CITY OF DELAND
REGULAR MEETING OF THE HISTORIC PRESERVATION BOARD
AUGUST 1, 2024 AT 5:00 PM
CITY HALL, COMMISSION CHAMBERS
120 SOUTH FLORIDA AVENUE

RE: **Historic Preservation Review (Exterior Alterations) for a commercial building at 309 N. Woodland Blvd.**
Application No.: HPB24-113
Applicant: Red Brick, LLC
Owner: 309 DeLand, LLC
Florida Master Site File: None
Zoning District: C-2A
Current Use: Professional Office

City of DeLand
HPB24-113
309 N WOODLAND
REMODEL

COLORED ELEVATIONS - E & W

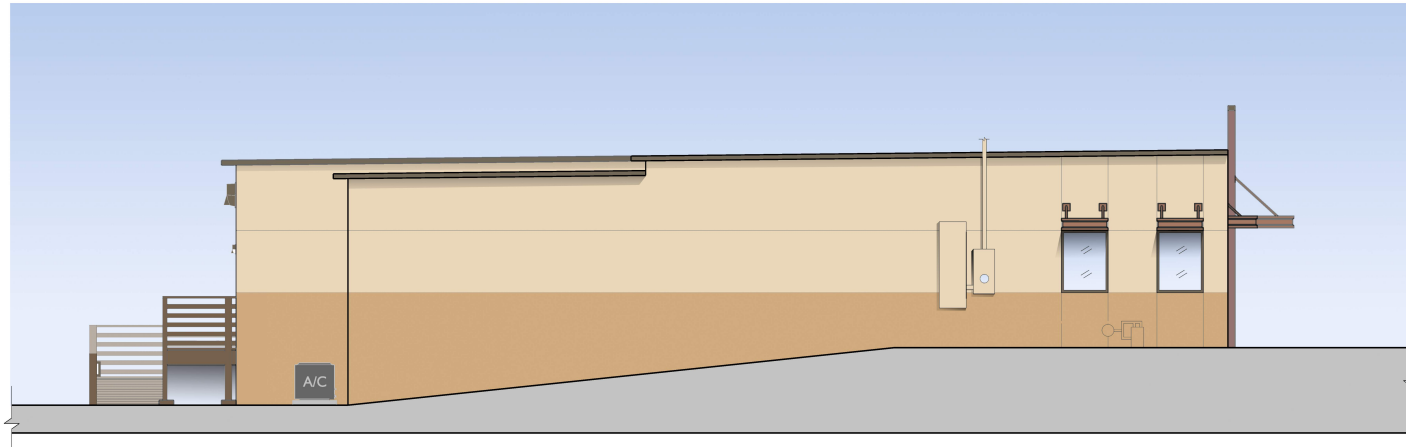
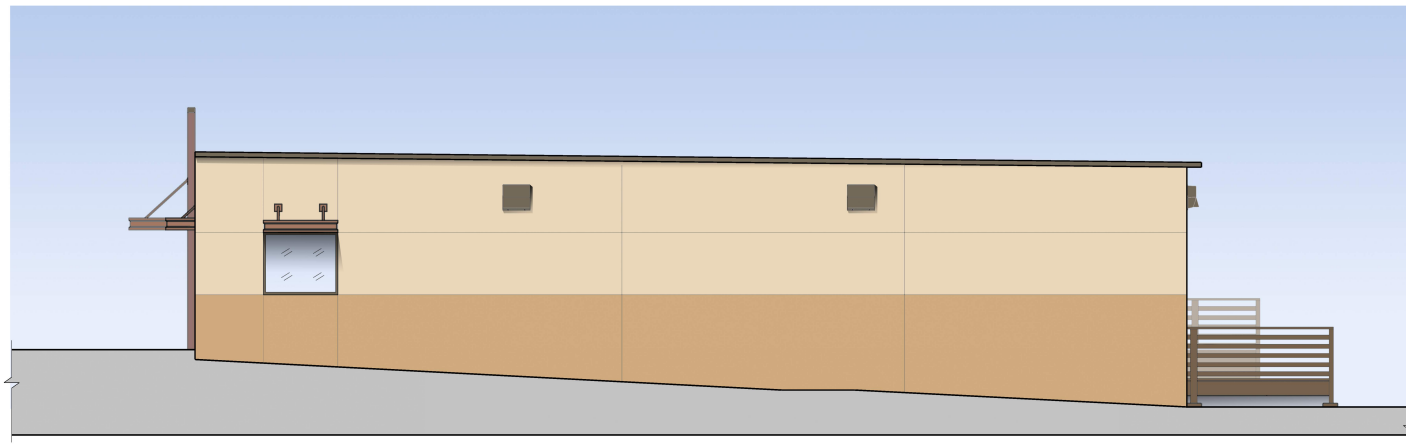
The existing building is mid-century modern, and the proposed façade design style is mid-century contemporary revival. The modifications to the building include removing the existing porte-cochère and enclosed entry portion on the front of the building, would result in reconfiguring the front façade, significantly changes the appearance and character of the existing building resulting in a flat front façade. Additional façade enhancements are necessary to provide adequate articulation. These enhancements have been included in the conditions of approval.

The existing building has many historic and unique characteristics and elements such as the large overhead sign, the awnings over the windows, the porte-cochère and enclosed entry portion. These unique features create an elevated front façade, add interest to the building, and represent a unique architectural style that is not present in today's building construction. The new proposed alterations remove all of these elements, resulting in a flat simplistic appearance, which differs from the existing building appearance.

- 1) Incorporate the following:
 - a. Red brick entry feature & wainscot around the building, creating a variation in materials.
 - b. More traditional awning style with corbels
 - c. More prominent roofline with a cornice and;
 - d. Color band around the building
 - e. Wall mounted lighting
- 2) Site lighting be corrected to ensure that illumination from any light source onto adjacent properties or into the public right-of-way shall not exceed 0.5 foot-candles.

A A3 PROPOSED BUILDING ELEVATION
WEST FACADE (FRONT) SCALE: 1/4"=1'-0"

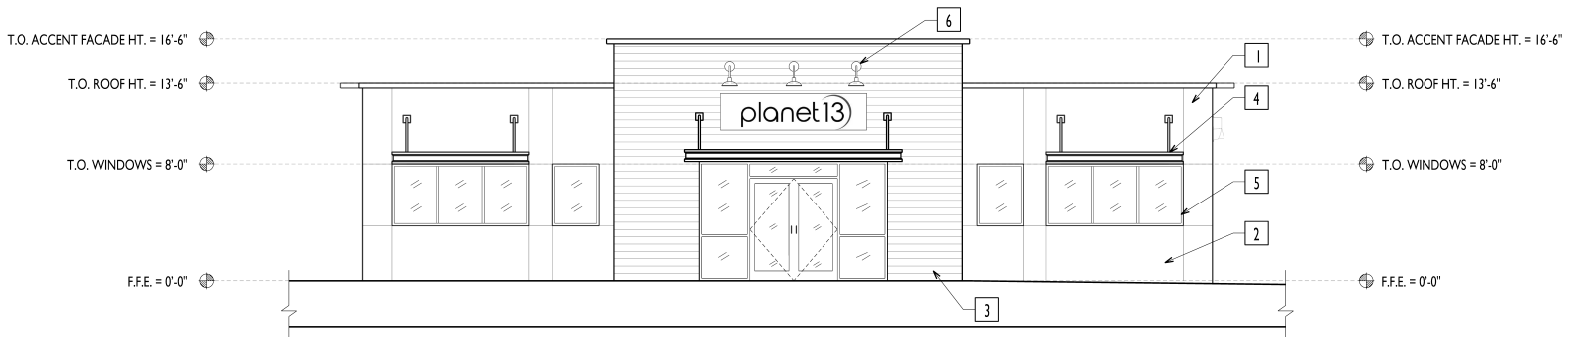
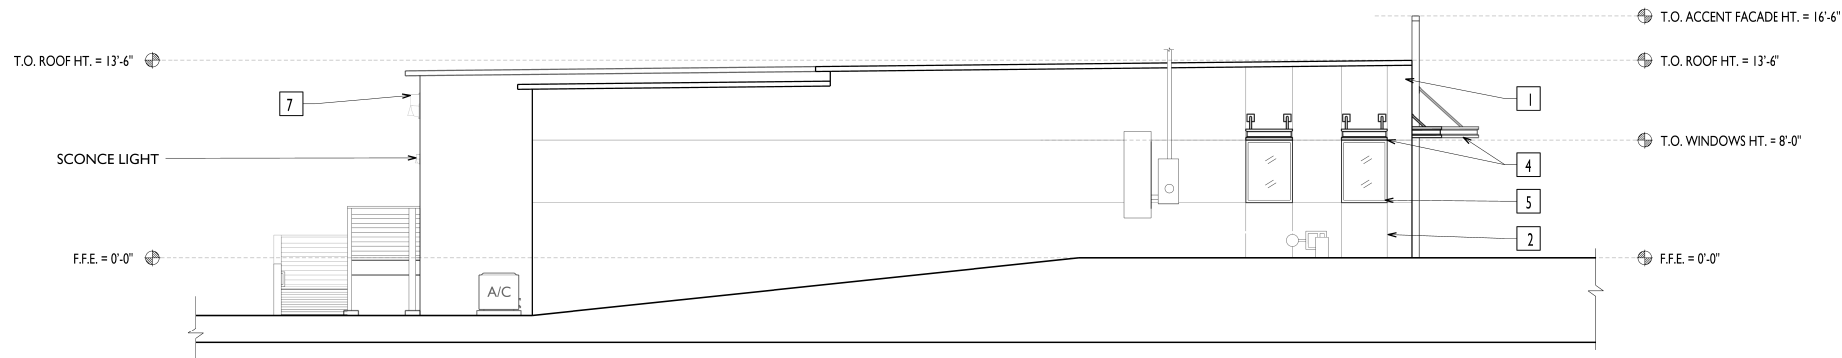
The existing building has a flat roof with a stepped down porte-cochère and enclosed entry portion, the proposed alteration removes the porte-cochère and enclosed glass entry portion and raises the main roof parapet to create a stepped entry feature. The stepped entry feature is consistent with the buildings within the entire district and surrounding buildings, but the existing porte-cochère and enclosed glass entry is what provides the existing building character, and the new alteration creates a more modern appearance.

The alteration would include removing windows/doors, but no additional windows/doors will be added. The removal of windows/doors is a result of removing the existing enclosed front entry portion, as it is entirely glass/windows therefore removing a primary characteristic of the existing building.

The existing building has a flat roof with a stepped down porte-cochère and enclosed entry portion, similar to the surrounding buildings that have parapets and enhanced rooflines. The existing building also has fabric awnings over the front windows, the exterior alterations proposes to install metal awnings in the same location, creating a more modern appearance. It is recommended the applicant incorporate a more traditional awning style with corbels or update the fabric awnings.

The glazing proposed would be impact resistant. However, staff is not certain if it is proposed to be tinted. The applicant should note that reflective tinting is prohibited.
